Development Assessment

Subject: Item 3.3 - Additional information and response from applicant to assessment report for DA2021/0311 Construction of a boarding house at 2 The Circle, Narrabeena

2 THE CIRCLE, NARRAWEENA – DA2021/0311
PROPOSED: NEW GENERATION BOARDING HOUSE - ITEM 3.3, 2 JUNE 2021
SUBMISSION TO THE NORTHERN BEACHES LOCAL PLANNING PANEL

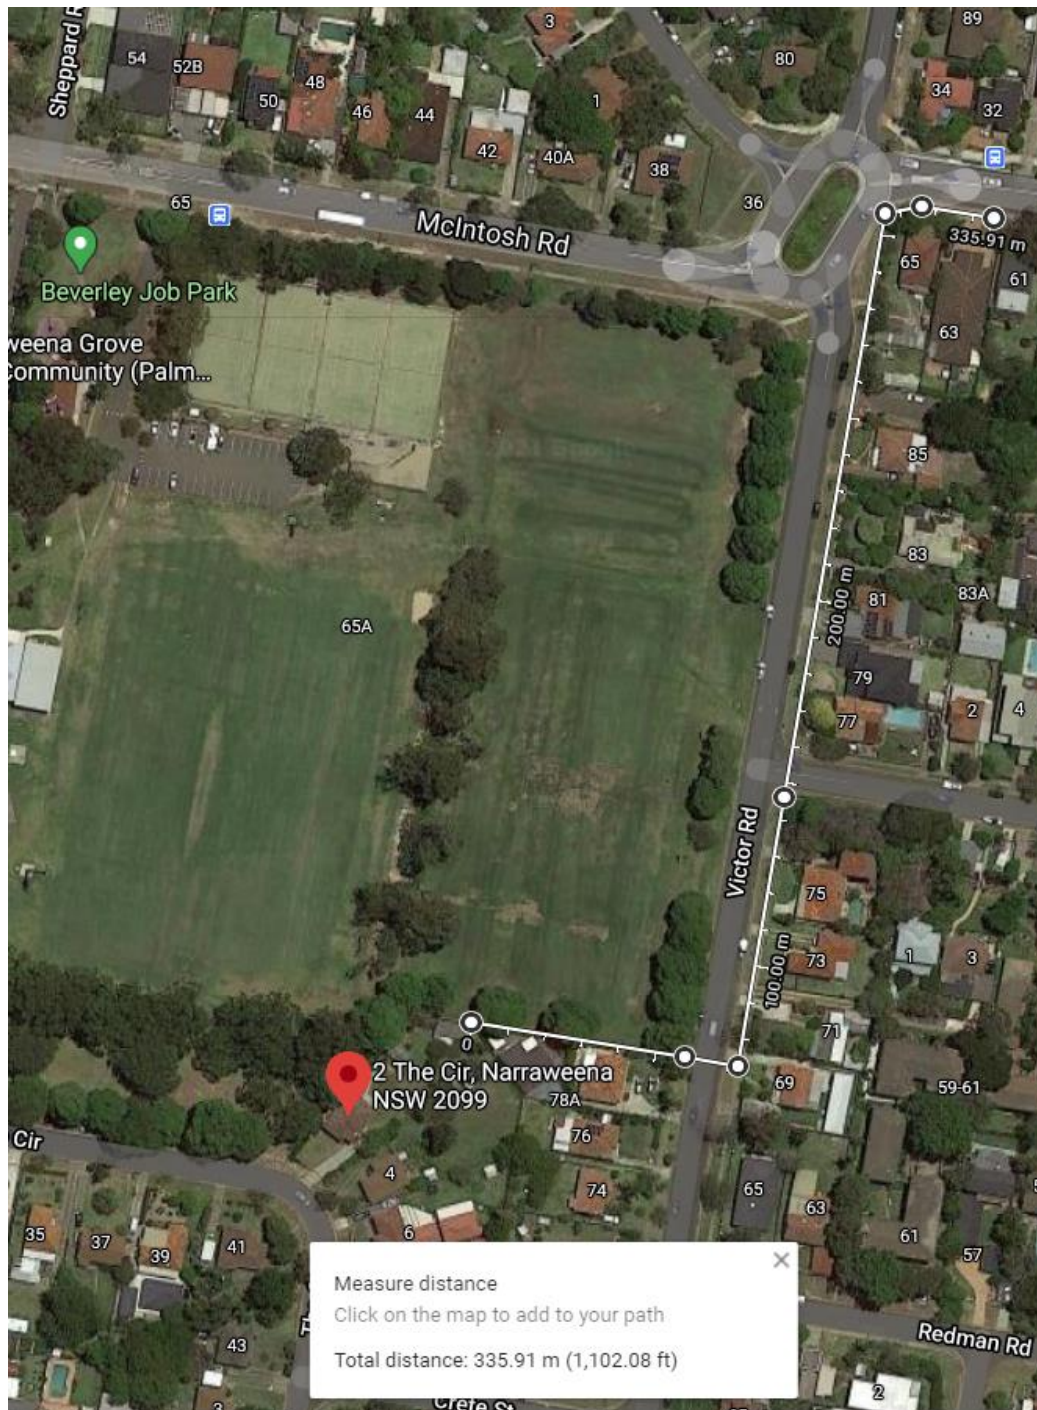
There is one determinative issue in this DA which is whether this site is within an accessible area as defined by State Environmental Planning Policy Affordable Rental Housing (SEPP ARH). The applicant relies on the high amenity parkland adjoining the site to walk 324m to the bus stop McIntosh Rd (figure 1). Council's position is that the site is not within an accessible area. This is based on the view that the park adjoining the northern and western boundaries of the site cannot be relied upon to satisfy the SEPP ARH's definition of 'walking distance'.

25. The gradient of the land is modest between the site and key facilities including the two regularly serviced bus stops on McIntosh Rd and the neighbourhood centre. There is a level change between:
 - the site and the bus stop on McIntosh (at Figure 1) of approx. 6m providing an overall gradient of approx. 2%
 - the site and the neighbourhood centre of approx. 8m providing an overall gradient of approx. 2%

DRAWING TITLE GROUND FLOOR PLAN	DRAWING NO. DA03	ISSUE: 1
---	----------------------------	--------------------

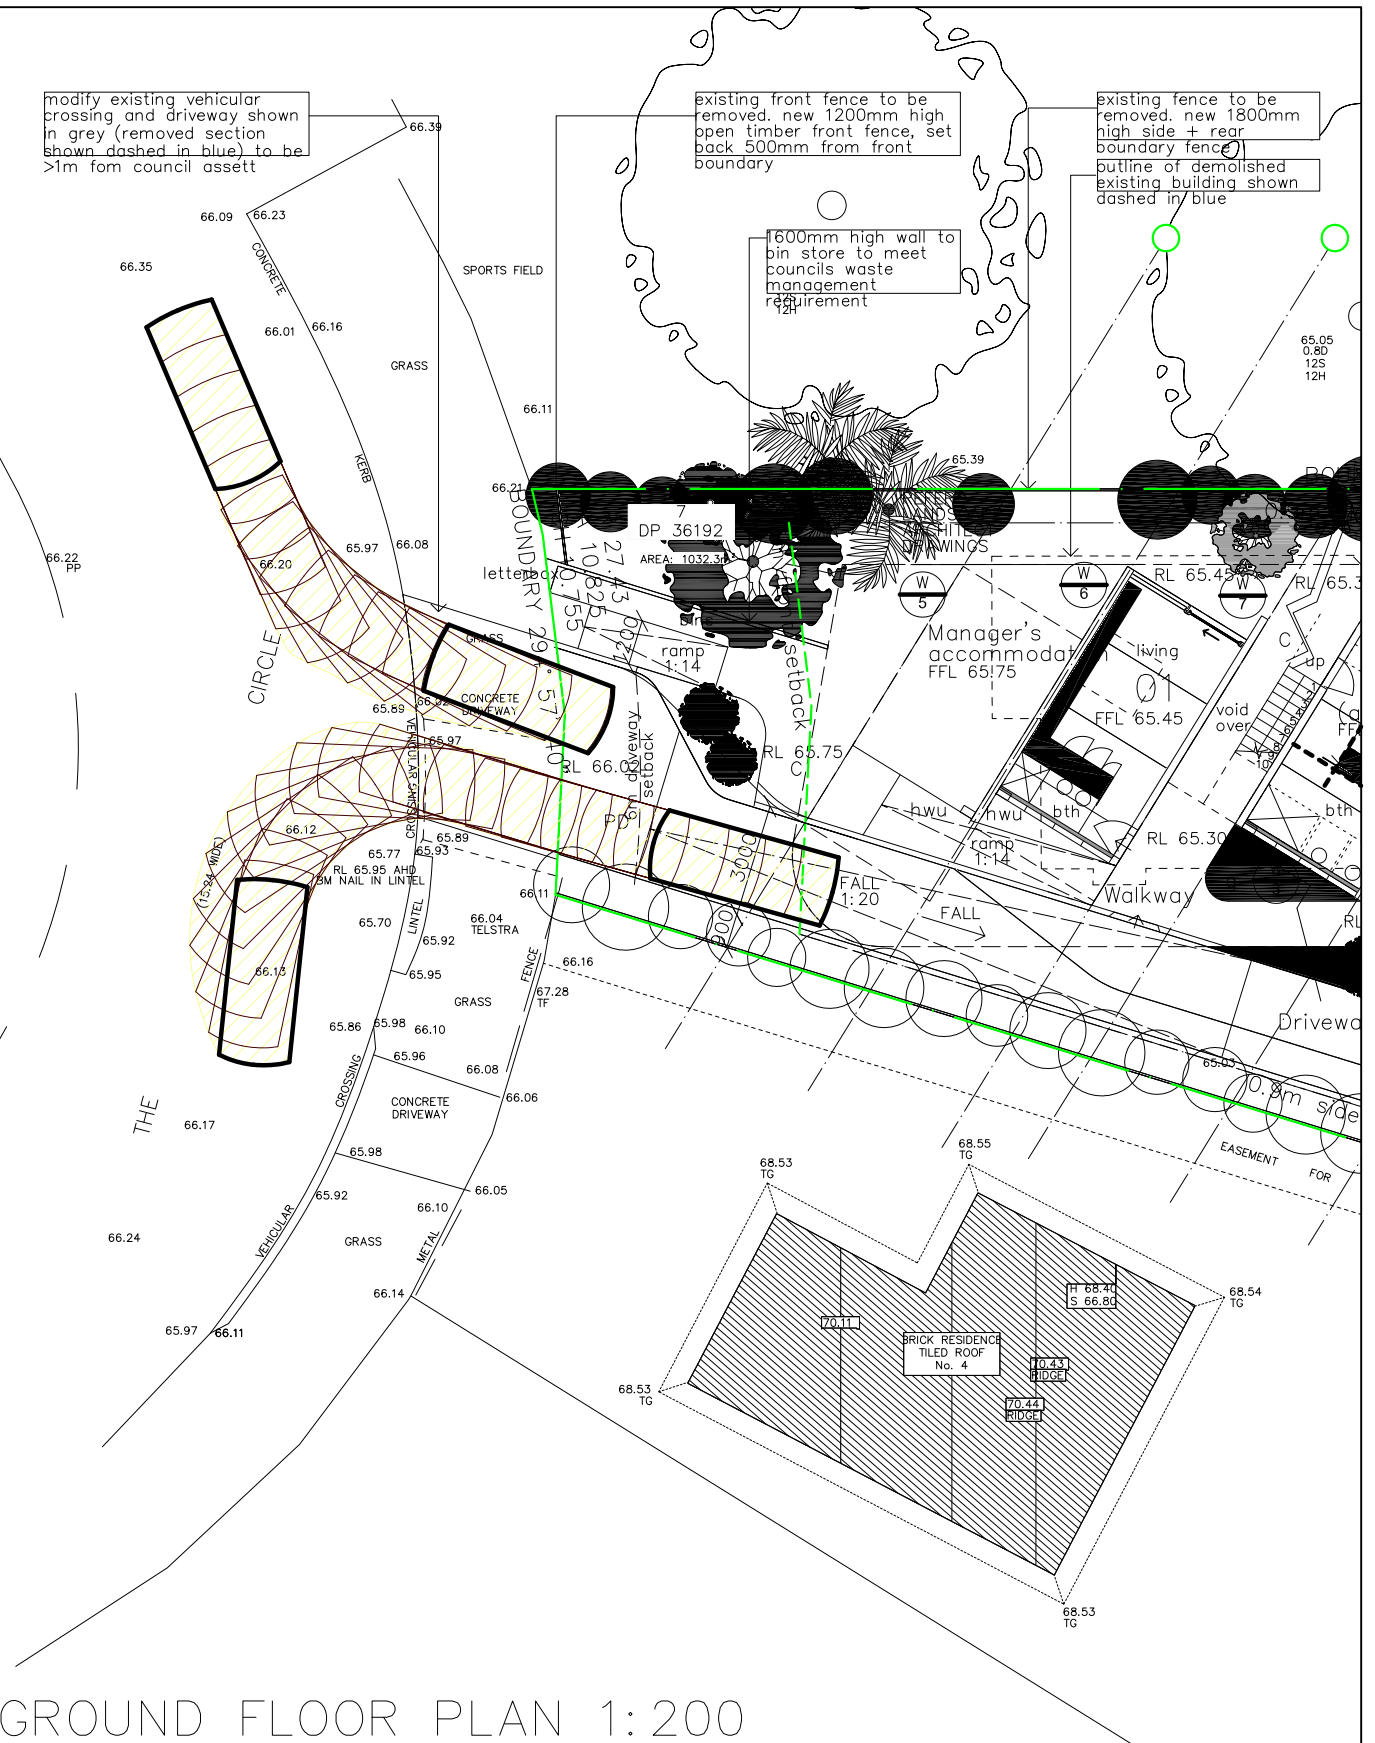
Council's traffic engineers have reviewed the submitted passing bay and swept path diagrams. The passing bay has been proposed partially within the subject site and partially within the road reserve, as well as a clearance of 1m to the drainage lintel. Council's traffic team are satisfied with this arrangement and therefore, reason for refusal No. 2 could be resolved.

37. The project architects have responded to design matters relating to the waste bin area, the location of stormwater drainage pipes and the driveway width at the entry to allow for the passing of 2 vehicles. Details regarding these matters are provided on the accompanying plans and the following aspects are noted:

38. The drawings have been amended to adjust the location of the proposed driveway 1m away from Council’s stormwater asset to achieve the council’s engineering requirement.
39. The easement is shown on the land survey that accompanies the DA. The proposal has considered this easement within the design, and furthermore has responded to Council’s feedback pertaining to it during the Pre DA. A photograph is provided at figure 6 below showing the concrete plate associated with the drainage line within the neighbouring property at 4 The Circle adjacent to the shared fence-line with the subject site.
40. It is understood that Council’s mapping layer, which conflicts with the survey information, is to be used as a guide rather than as an accurate representation of the pipe’s location. In the interest of resolving this issue, the client is in the process of engaging a suitably

41. The amended drawings address Councils' recommendations by changing the location of the bin store to be adjacent to the length of the pedestrian entry pathway. It is not a 'waste room' so does not need to comply to the recommendations that pertain to a 'room'. The previously labeled 'store' has been removed. The slope is less than 1:8, so complies with Council's gradient. The wall to the bin store has been increased to 1600mm as requested.

42. Issue: Width of driveway at the entry is to allow for the passing of 2 vehicles.
43. The drawings have been amended to provide a passing bay. The project's traffic expert states as follows:

Despite the fact that AS2890.1 does not require an ability for cars to pass on a driveway connecting to a local access road, the modified driveway provides for cars to pass. AS2890.1 Section 3.2.2 specifies that an access driveway on an arterial or sub-arterial road or where sight distance is restricted on a traffic movement of more than 30 vtp, there should be a passing bay available within the site.

The subject driveway does not involve any of these circumstances and in reality, a driver waiting to exit will wait at the kerb line and not at the site boundary. The attached swept path diagrams show the circumstances for the proposed modified driveway where a car waits to exit while a car is able to pass to enter and where an entering car waits while a car exits.

modify existing vehicular crossing and driveway shown in grey (removed section shown dashed in blue) to be >1m from council asset

1600mm high wall to bin store to meet councils waste management requirement
